Chemung County Stormwater  
Construction Inspection  
Erosion and Sediment Control

Project Name: Williams Honda	Date: 8/13/15
Location: CB 64 Big Flats	Permit #: NYR10
Weather Conditions: <i>Sunny</i>	Entry Time: <i>3:21</i>
On-Site Representative Present: Gene Beers	Exit Time: <i>3:45</i>

<b>PROJECT:</b>	Williams Honda
	Town of Big Flats
	Municipal Inspection

Water Quality Unit's 1 and 2

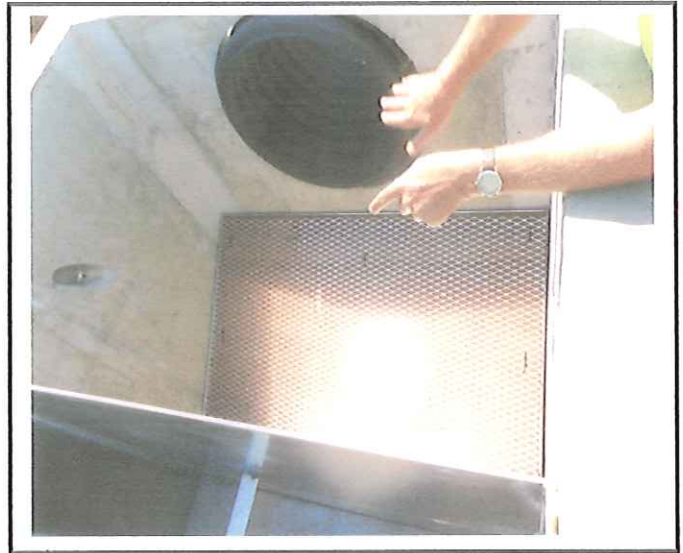
-contractor has some questions on the maintenance of these treatment tanks. the lid size doesn't match the coconut mat needing to come out of the tank.
